U.S. Department
Of Transportation
**Federal Highway
Administration**

Refer to: HNG-14/SS-59

Geometric and Roadside Design Acceptance Letter SS-59

Figure 2. Details of the lap splice connection.

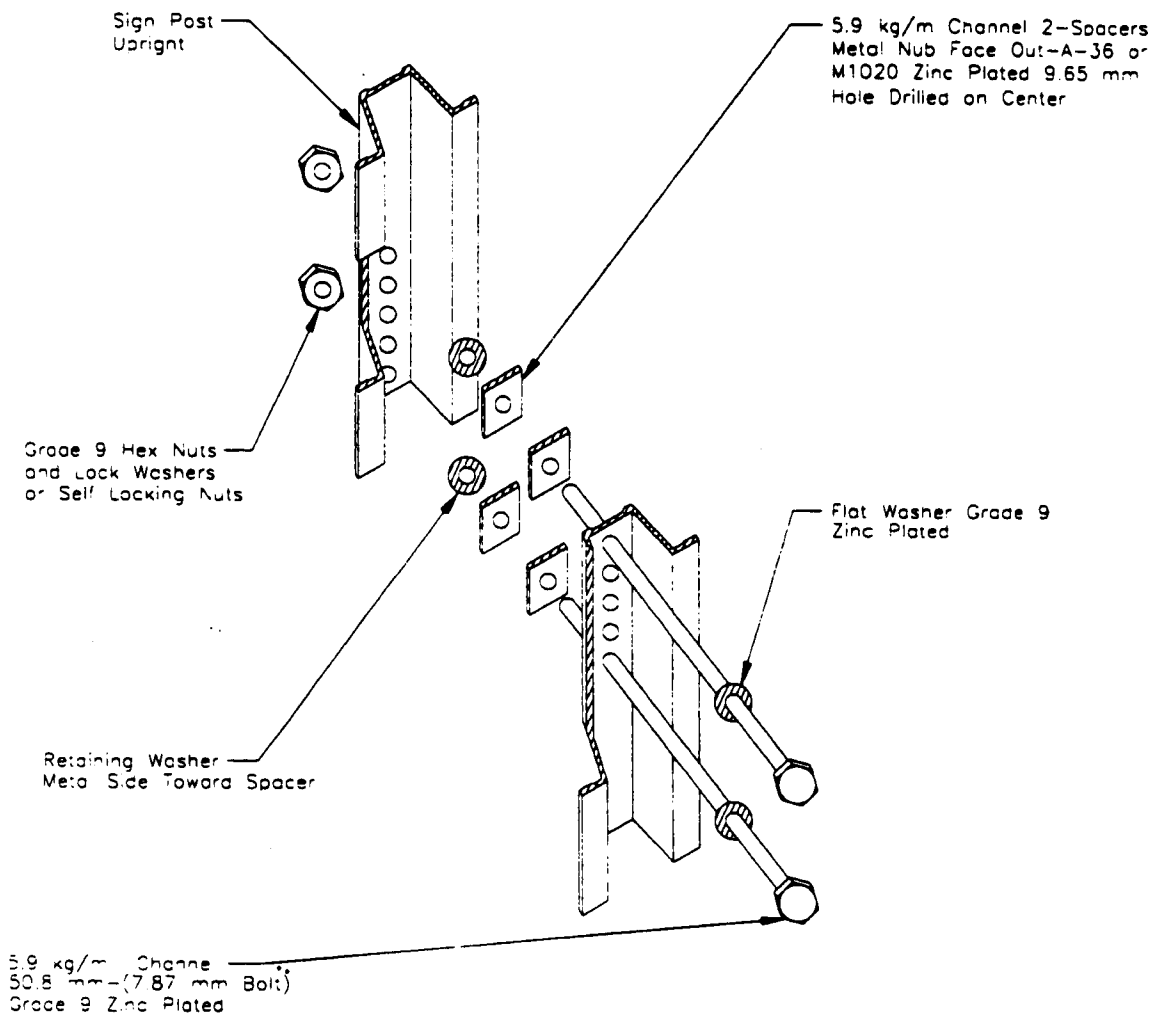
A drawing of the "Safety Splice" and a drawing showing installation details are enclosed. The 356-mm square by 6.3-mm thick soil plates are bolted on the stubs and are an integral part of the breakaway support design for use in weak soils. The full-scale crash testing of the spliced triple-post, 5.9-kg/m, 414-Mpa (60-ksi) steel sign support is summarized in the table below. The three 915-mm long support stubs were driven into the strong (S-1) soil leaving 102 mm of the stubs exposed. In the weak (S-2) soil test the stubs were 1525 mm long with 102 mm of each stub exposed. The tops of the soil plates were set 153 mm below the ground line. The stubs were spaced 457 mm on center. The top elements of the sign supports overlaps the stubs by approximately 150 mm, and were connected to the stubs by two 5/16-inch x 2-inch (8-mm x 51 mm) HS Grade 9 steel bolts. With each bolt there were a Grade 9 cut washer, two spacers, a retaining washer, and a self-locking flange nut.

The splice bolts were spaced 102 mm on center. The 25.4-mm square, 9.5-mm thick spacers are each punches with an 11-mm hole. Two spacers are placed back to back at each splice bolt location between nested u-channels.

Figure 1. Details of the Chicago Heights Steel break-away sign support installation.

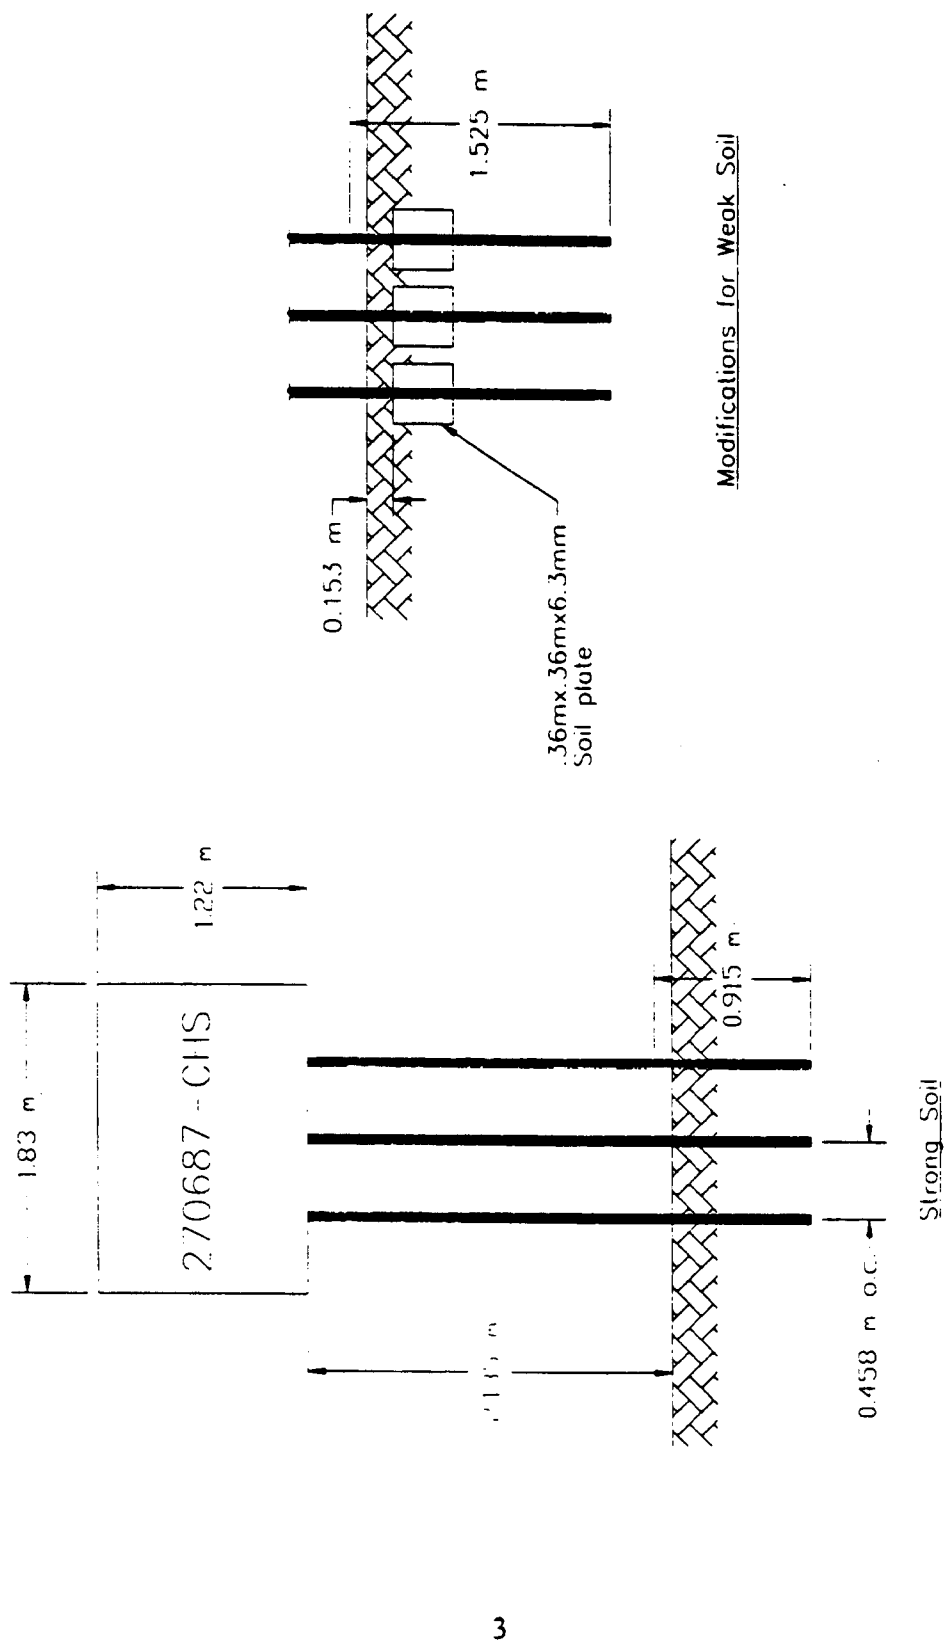
These results meet the change in velocity and stub height requirements of FHWA and AASHTO. Extensive testing on spliced 413.7-Mpa (60-ksi) u-channel sign supports show that the low-speed tests are the “worst case” compared to high-speed tests. Thus, we do not believe high-speed tests are necessary. Therefore, your company’s u-channel sign supports weighing up to and including 5.9 kg/m (4 pounds per foot), as described above and shown in the attached drawings, may be used on the National highway System, (NHS) when requested by a State, in installations using one, two or three supports within a 2.1-m span in standard soil or with soil plates in weak soil.
